Updated Draft Changes to the Estuarine Shoreline Stabilization General Permit Rules

Bonnie Bendell

July 26, 2007

DWQ's Objections

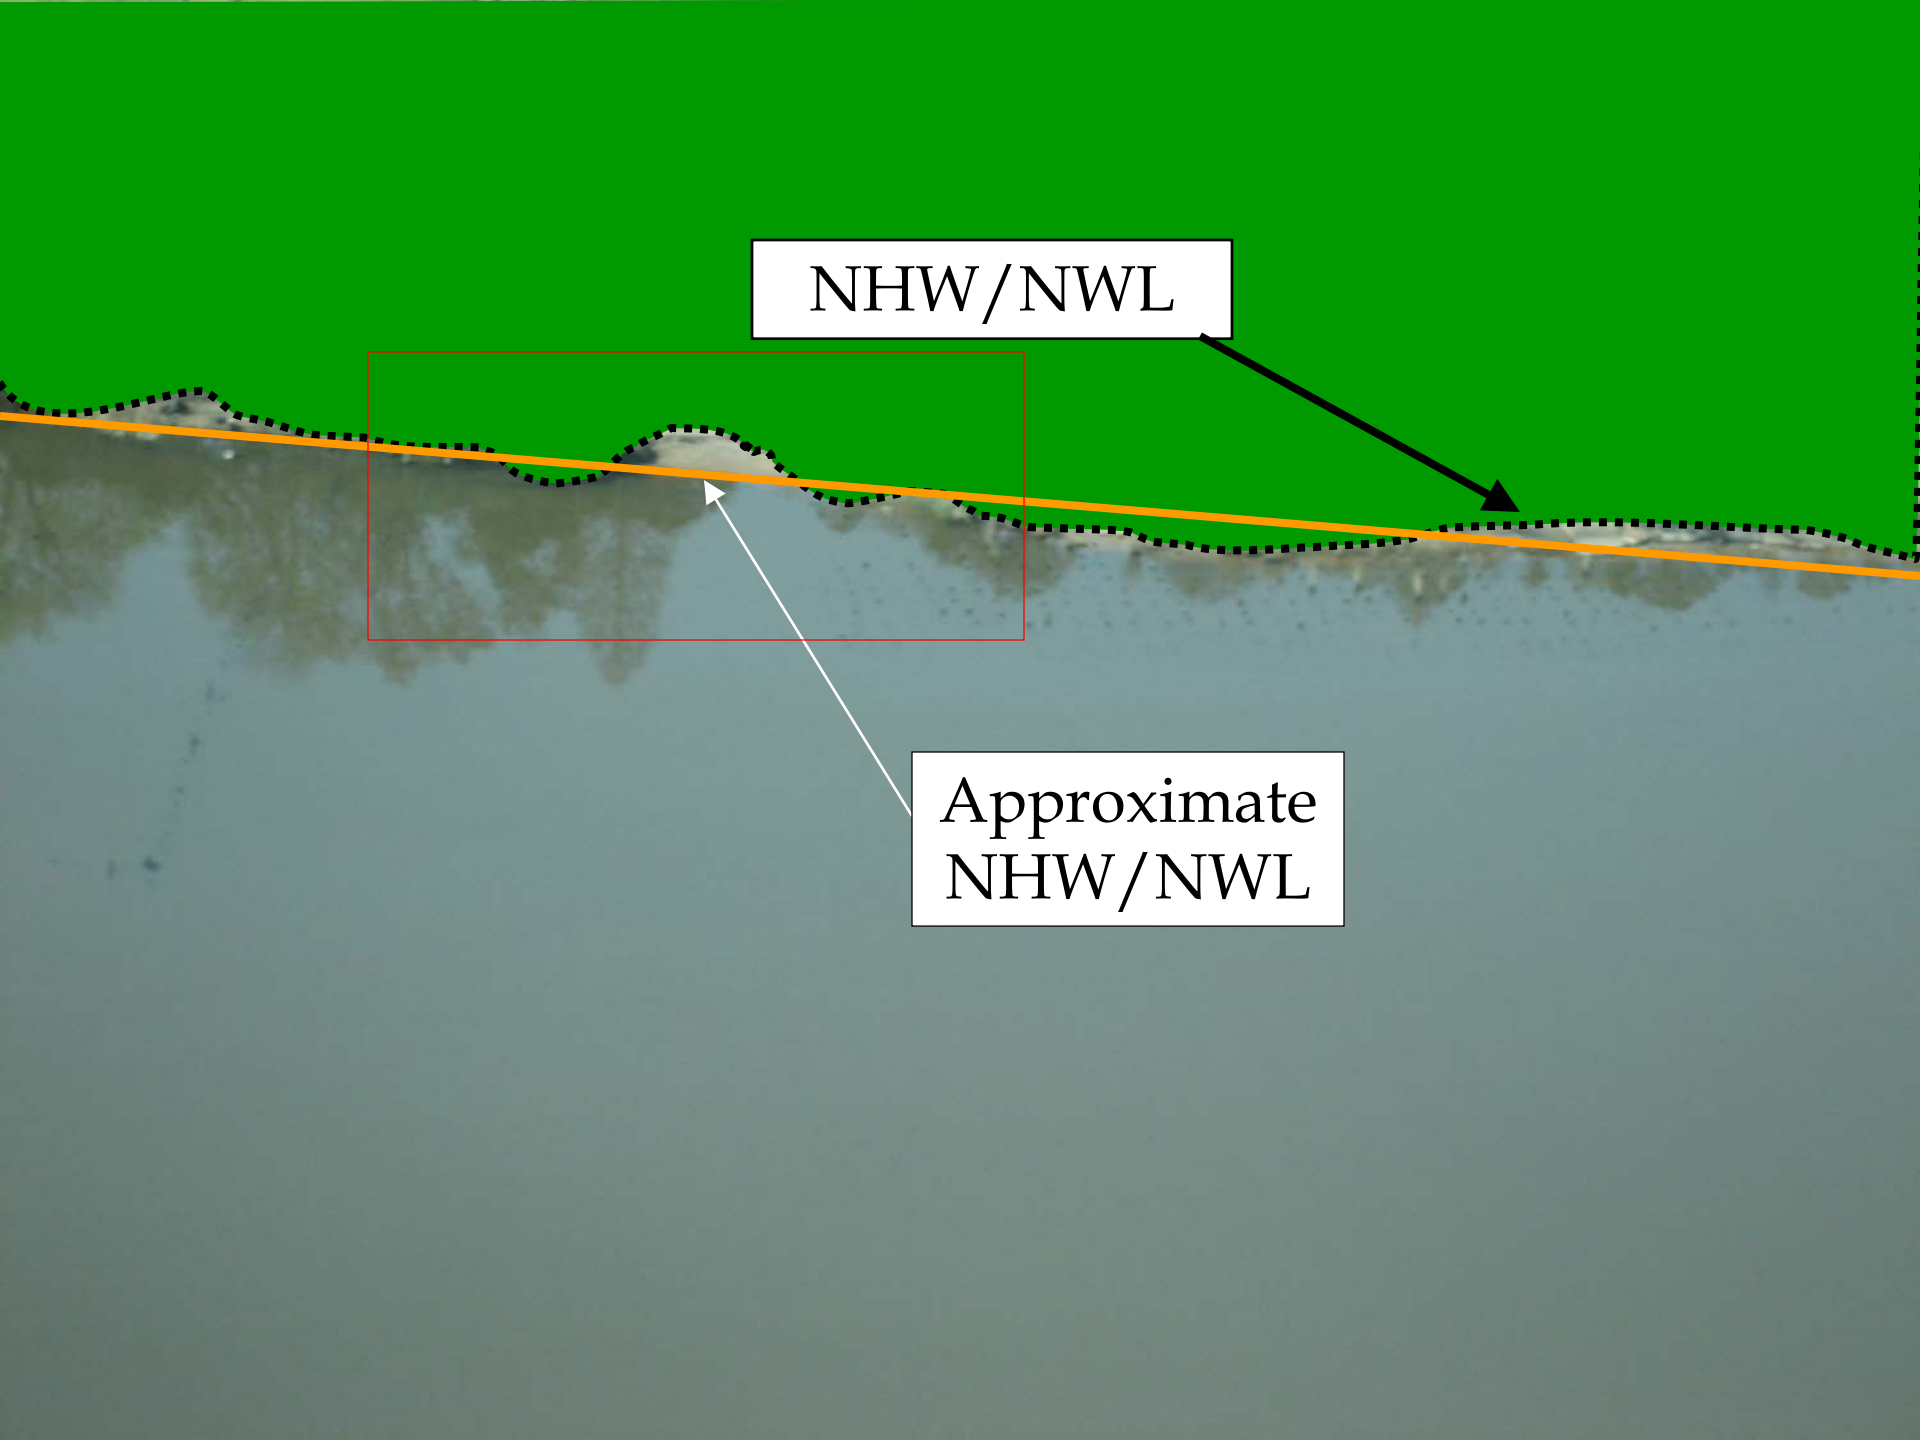
- Currently allow bulkheads an average of 2 feet with a max of 5 feet waterward of NHW/NWL
- Last meeting – Place bulkheads an average of 5 feet landward of NHW/NWL
 - Required many exceptions due to the location
 - DWQ objected to the proposed change

- Reduces the area of the Water Quality Zone 1 Buffer by approximately 17%. DWQ Zone 1 is intended to be undisturbed vegetation.
- Does not avoid or minimize impacts to the riparian buffer.
- Is no longer streambank stabilization. It is activity in the buffer and is adding impervious surface in Zone 1, which is prohibited in the buffer rules, and is only permissible through a Major Variance from the EMC.

Option A – Approximate NHW/NWL

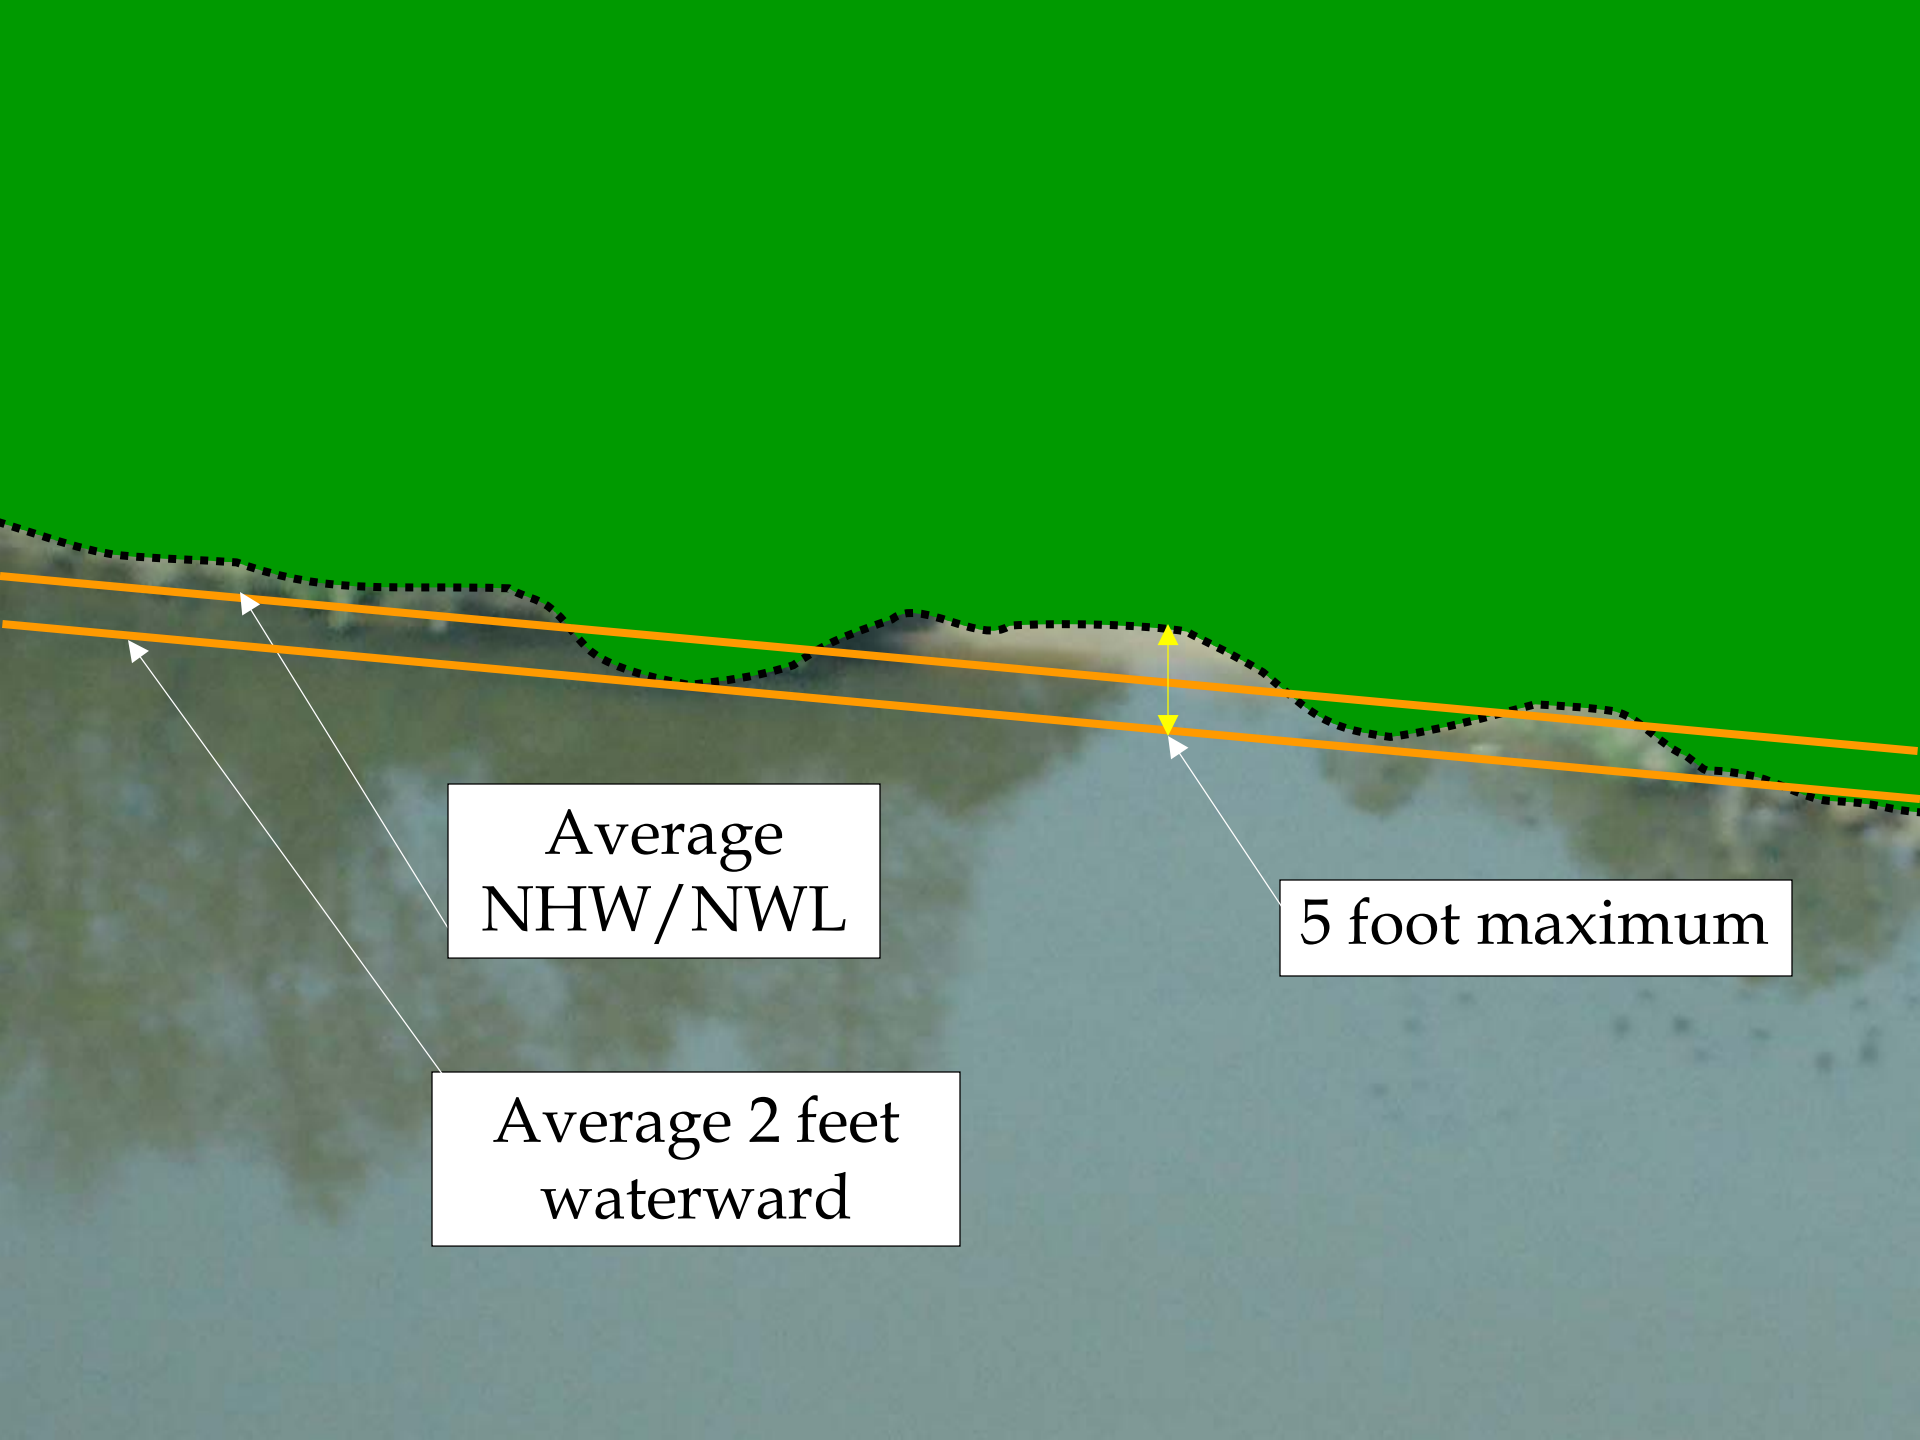
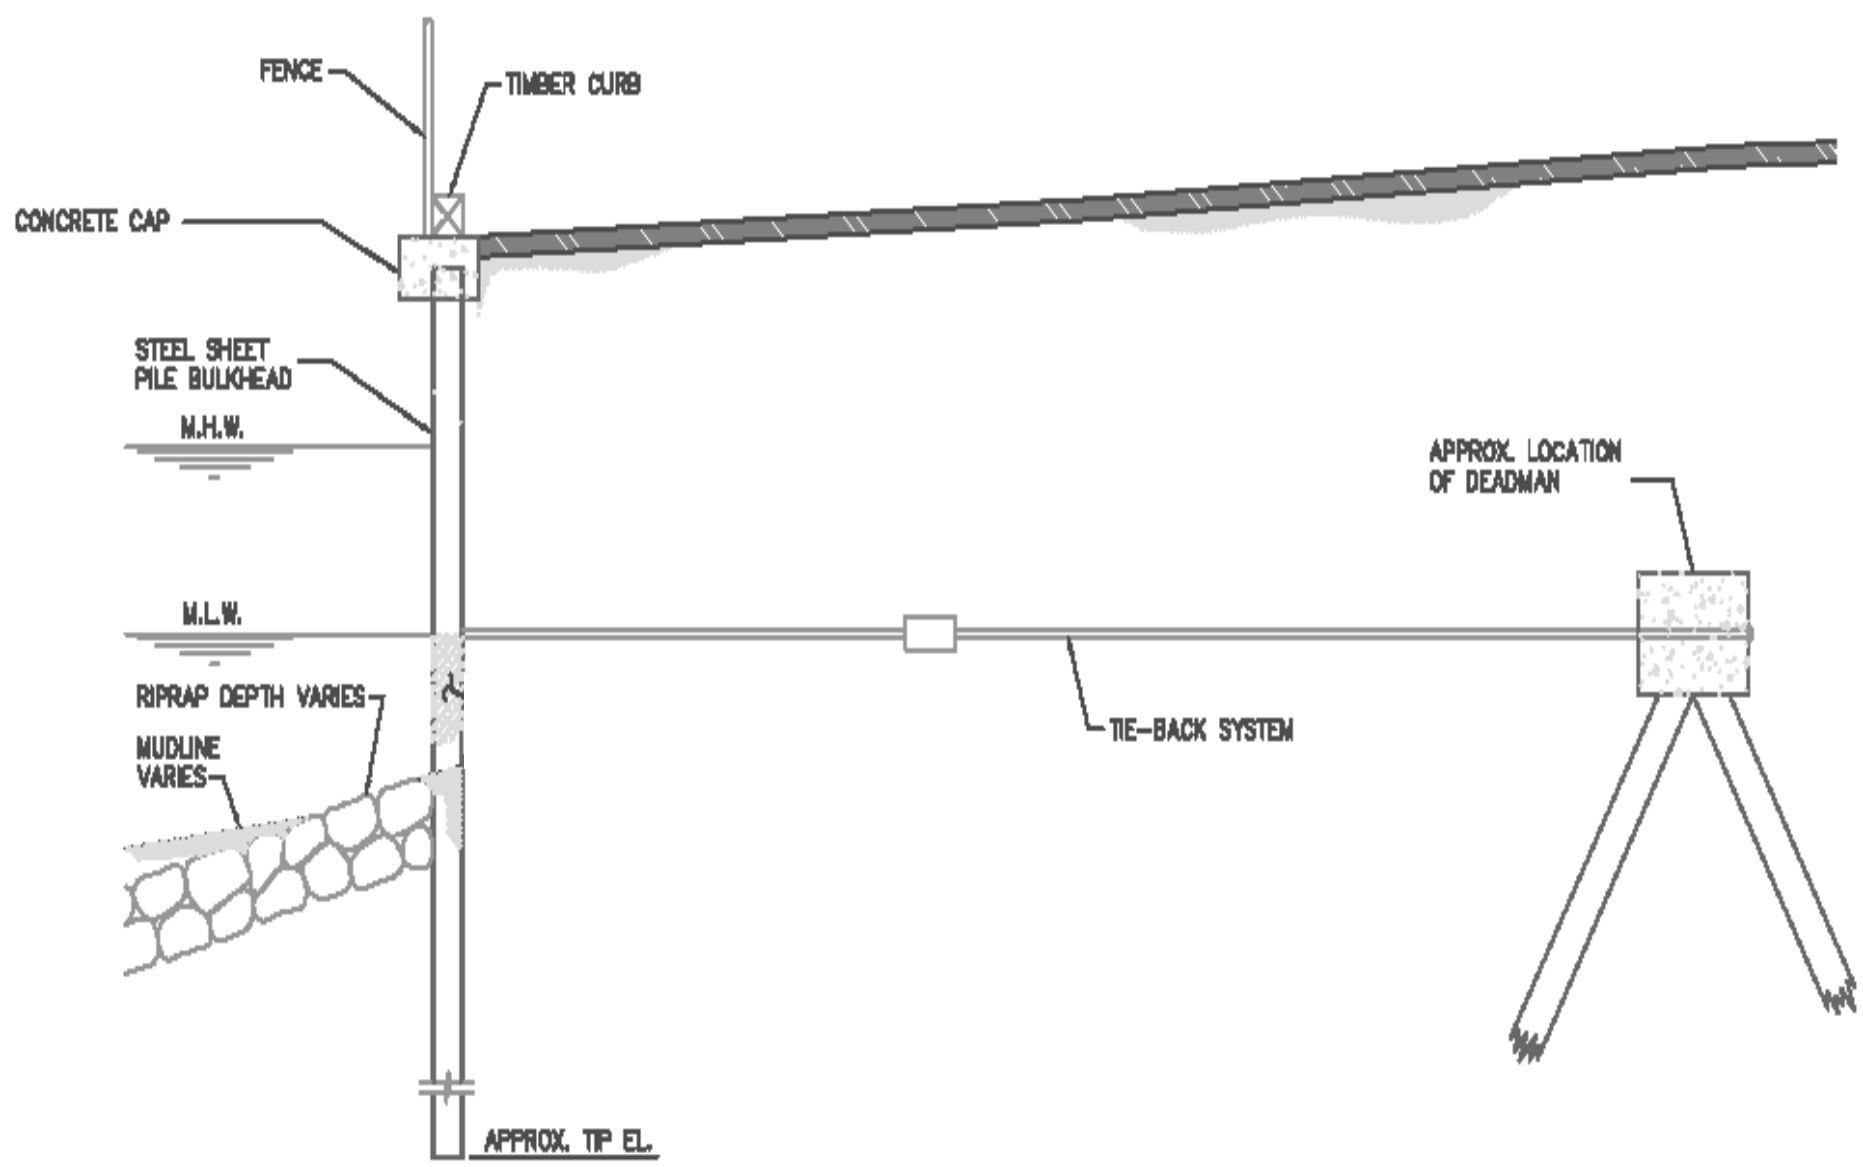
- Approximate NHW/NWL with a maximum of 5 feet waterward at any point along its alignment

- Protects shallow water habitat by moving bulkheads landward 2 feet as compared to current rules
- Protects public trust rights by moving out of them
- Very uncomplicated rule – same basic concept as the current rule

Option C – Bulkheads avg of 2 feet with riprap or NHW/NWL

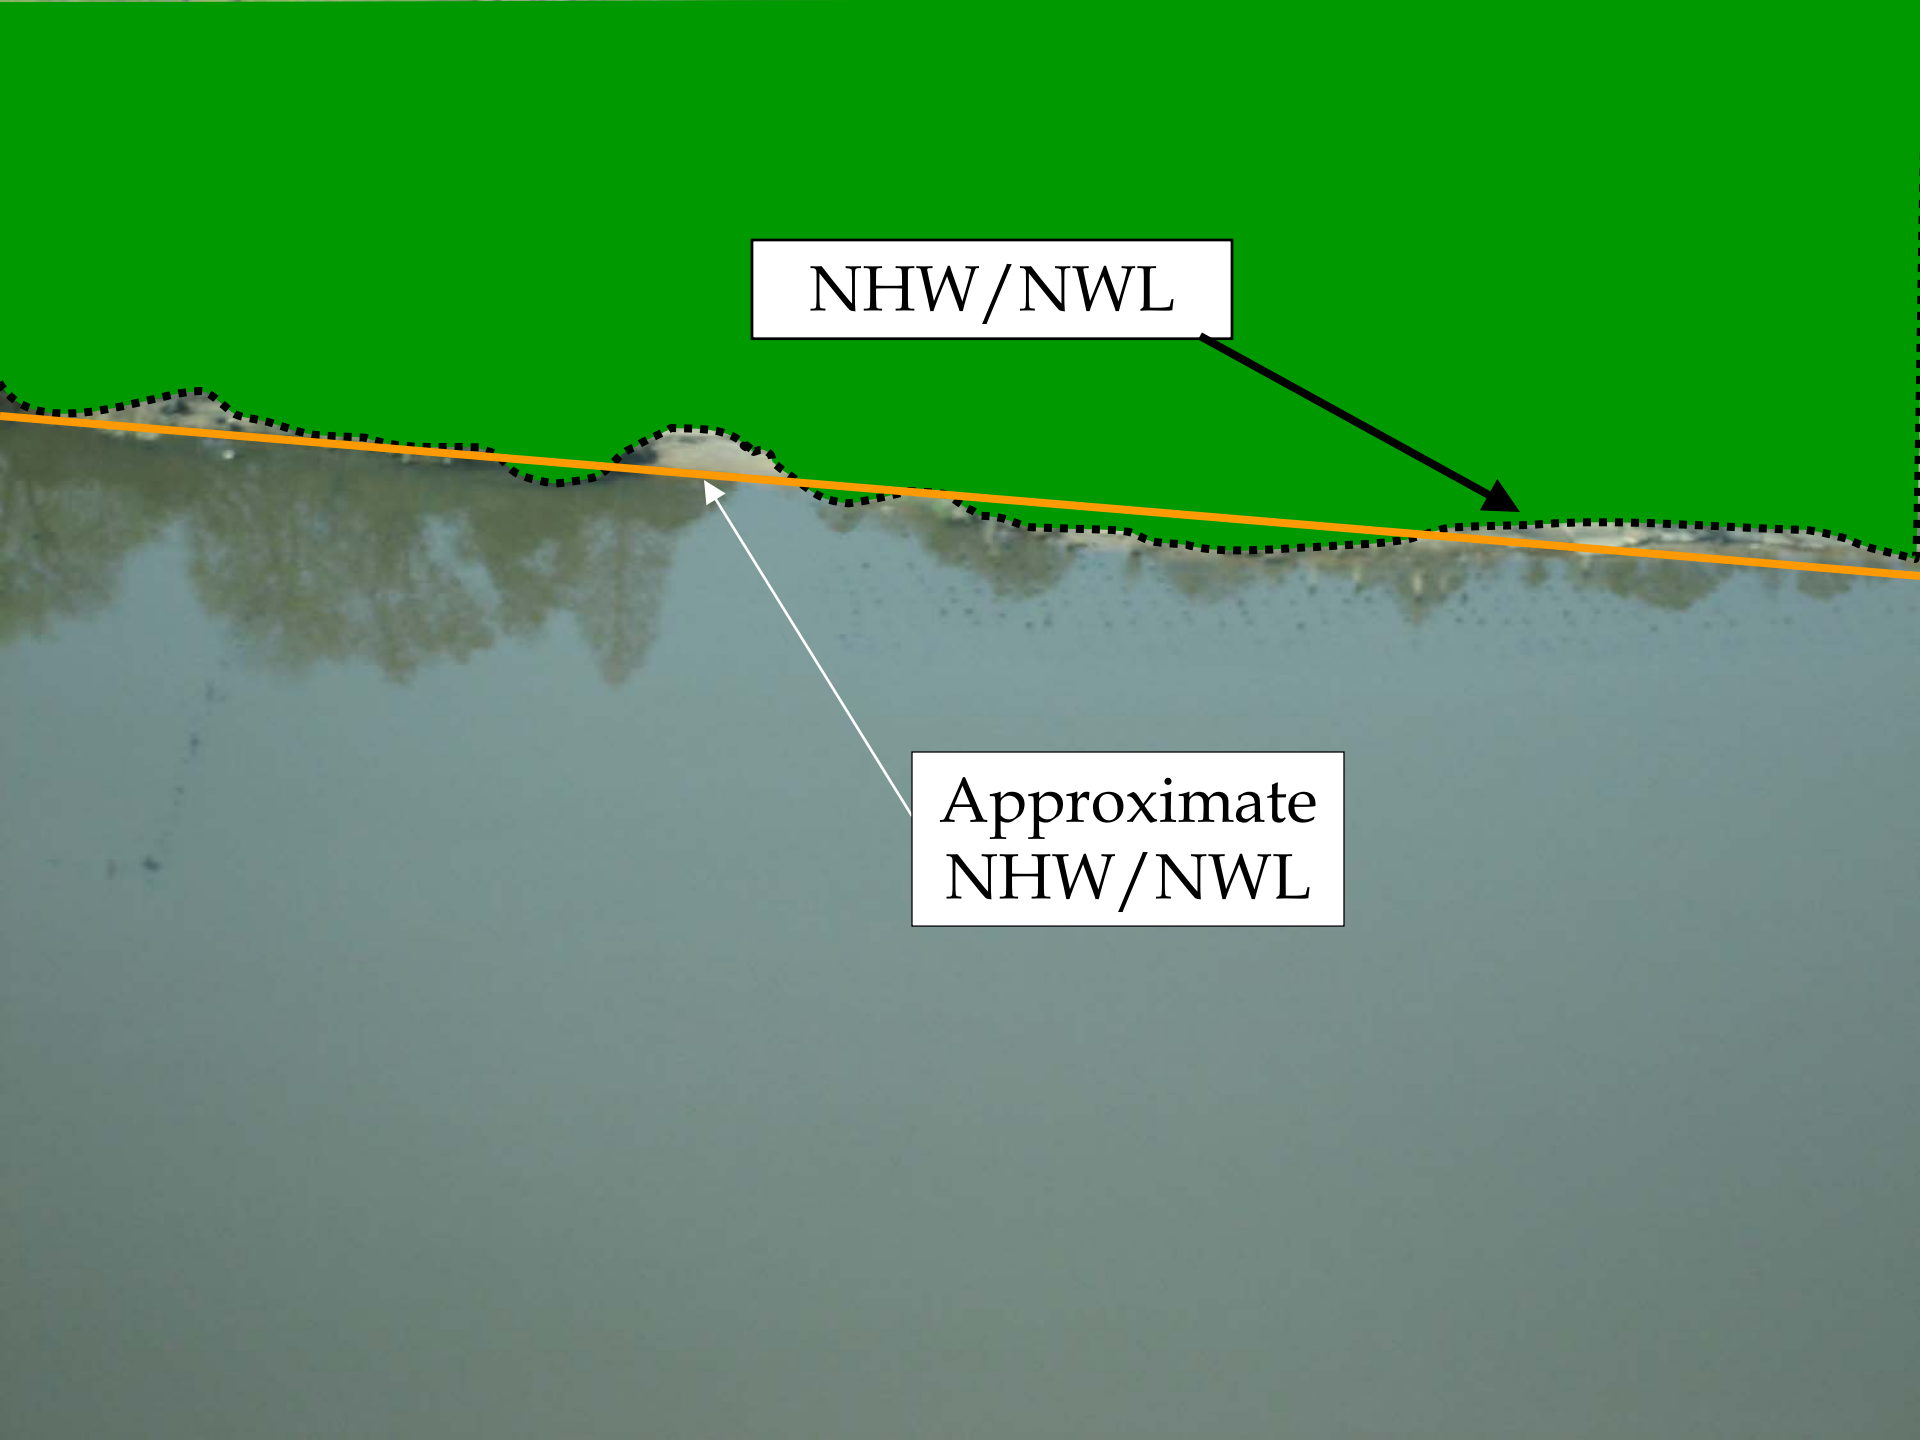
- Allow bulkheads a maximum average of 2 feet with a max of 5 feet waterward of NHW/NWL (which is what we currently allow)
- Any new bulkhead that approximates a location waterward of NHW/NWL will be required to place riprap at the bulkhead toe

- Bulkhead in the water – add rock to create fisheries habitat.
- Bulkhead at NHW/NWL – protecting the shallow water habitat by moving it back
- Flexible – yet protective rule that balances protection and flexibility
